## Chrysler 45RFE, 5-45RFE, 65RFE, 66RFE & 68RFE

**2476, DP2476, 2350, DP2350, 2505, DP2505, 2506, DP2506, 2543, DP2543, 2544 & DP2544**

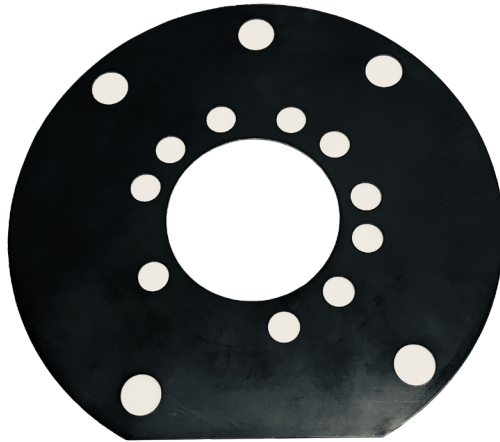
Original, factory built 45RFE, 5-45RFE and 65/66/68RFE units did not include a pump stator to pump cover gasket. This can lead to cross leaks in the area, caused by poor machining and possible warpage. To eliminate these leaks Freudenberg-NOK engineers designed a rubber coated metal gasket to seal the pump stator to pump cover. The new gasket, part number **B10486** is available exclusively in TransTec® brand 45RFE, 5-45RFE and 65/66/68RFE overhaul kits.

**\*\*All Chrysler 45RFE, 5-45RFE and 65RE kits built after 2/16/18 include gasket B10486\*\***

**\*\*All Chrysler 66RFE and 68RFE kits built after 5/10/18 include gasket B10486\*\***
